**Historical Architectural Review Board
COA Preliminary Review Sheet**

HDC-2024-00085

Address: 953 Turner Street

Proposal: Remove deteriorating fence and shed and grade-level deck and create 2-car parking pad with apron.

Fenceline to be partially removed (Applicant)

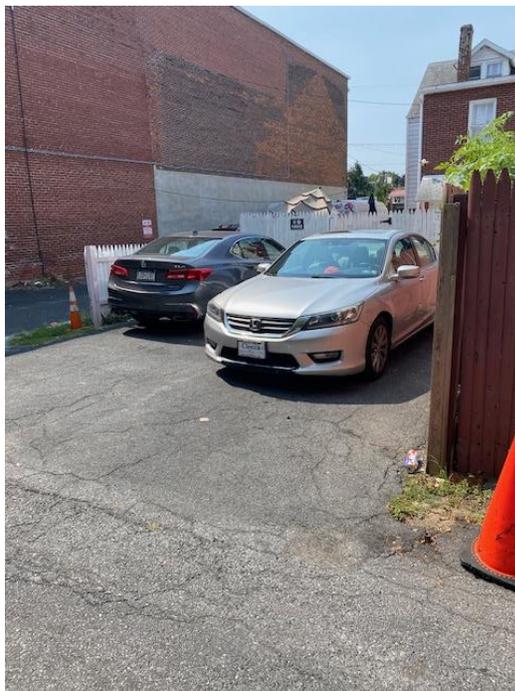
Observations & Comments: The existing shed and fencing proposed to be demolished are not historic and not contributing to the historic district. The application does not indicate if any fencing is to be installed after the proposed work. Staff note that if a fence is to be installed in the future, the applicant should submit the design and material of the fence to be reviewed by staff.

The applicant noted that only the 6' tall portion of stockade fence is to be removed. There is an existing 3' fence, approximately 10' long, from the house to a utility pole that will remain. Mr. Huber asked for the applicant to clarify the location of the deck to be removed. The applicant stated that the deck is at grade, adjacent to the shed. Since the deck is not visible from the public right-of-way, it is not in HARB's purview. Mr. Jordan expressed concern about the sightlines and affect to the form massing of the removal of the fence and the change to the historic streetscape. The visual sight from standard height on the street would be affected by the removal of the fence. Nothing was shown on historic maps or shown in imagery that indicated a historic fence.

- If a replacement fence is to be installed, refer to Guidelines Section 3.12 and submit design and material of replacement fence.

Shed to be Removed (Applicant)

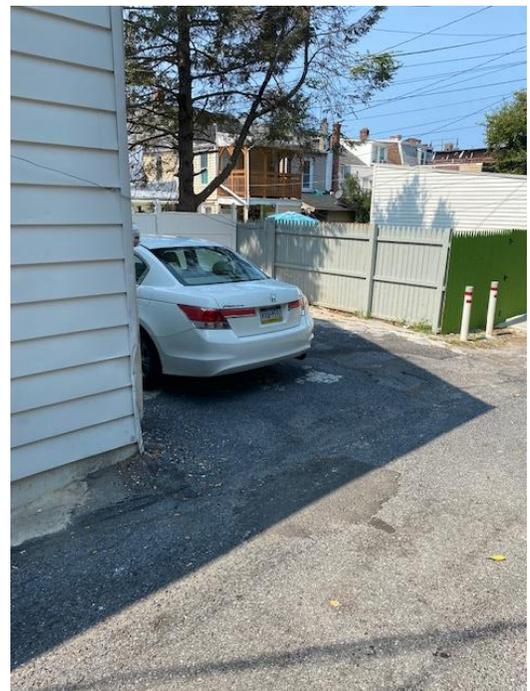
Mr. Jordan summarized that the deck is outside HARB purview. The shed is not historic, and no board members raised concern about its removal. Discussion continued for the demolition request for the fence. There was no evidence in the application materials or Sanborn Maps that the proposed fence line to be demolished is a historic street wall. Mr. Jordan acknowledged that half and quarter streets play an important role in an historic district's urban integrity. Mr. Encelewski stated that if any future property owner does not desire a parking pad, they would be likely to install a replacement fence to enclose the yard. Mr. Franzone noted that the demolition of the fence should be allowed, given the absence of proof of a historic street wall.
